Service Bulletin
Disabling of Tamarack ATLAS System

CAS/M0132 Issue B

EASA STC 10056170

Modification Nos. CAeM/Cessna/1375, CAeM/Cessna/1430, CAeM/Cessna/1440 and
CAeM/Cessna/1452

Figure 1 Locations for Speed Tape (Upper and Lower Surfaces)

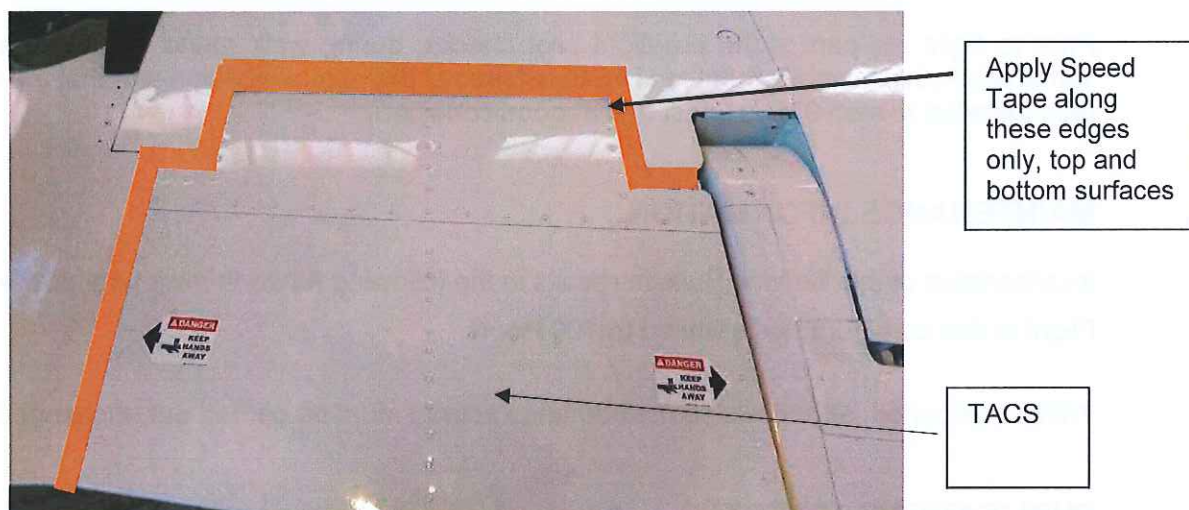
Issue	Date	Author	Detail of Changes
A	18 Apr 2019	PJH	Original Issue
B	30 Apr 2019	GM	Raised in issue to clarify the use of Speed Tape. Para 9c) added with cleaning instructions. Step 9d) (was 9c) reworded with additional installation instructions. Figure 1 added – annotated photograph of TACS with required Speed Tape areas added.

- d) Ensure all surfaces are dry prior to application of tape then apply Aluminium Foil Tape (3M^T 425 Aluminium Foil Tape, Nashua 324A Cold Weather Tape or Shurtape AF100 are acceptable) of no less than 2.5" (63.5mm) width, over all the gaps around each TACS on the forward and outboard sides only (see Figure 1), on both upper and lower surfaces and evenly across the gap, to ensure that free movement of the TACS is not possible. Check that the tape is well pressed down, especially at the edges, and that there are no gaps or raised portions. Ensure that free movement of the aileron is unaffected. If the specified tape is not available, requests for the use of an alternative tape type or manufacturer must be made to the Design Organisation in the first instance, see Section 10 for contact details.

- c) With the TACS in the faired, neutral position, clean the area on and around both the port and starboard TACS with a mild detergent or any other approved cleaner listed in the Cessna AMM and dry using a soft, lint-free cloth. Ensure at least 1.5" (37mm) on each side of all gaps is cleaned.
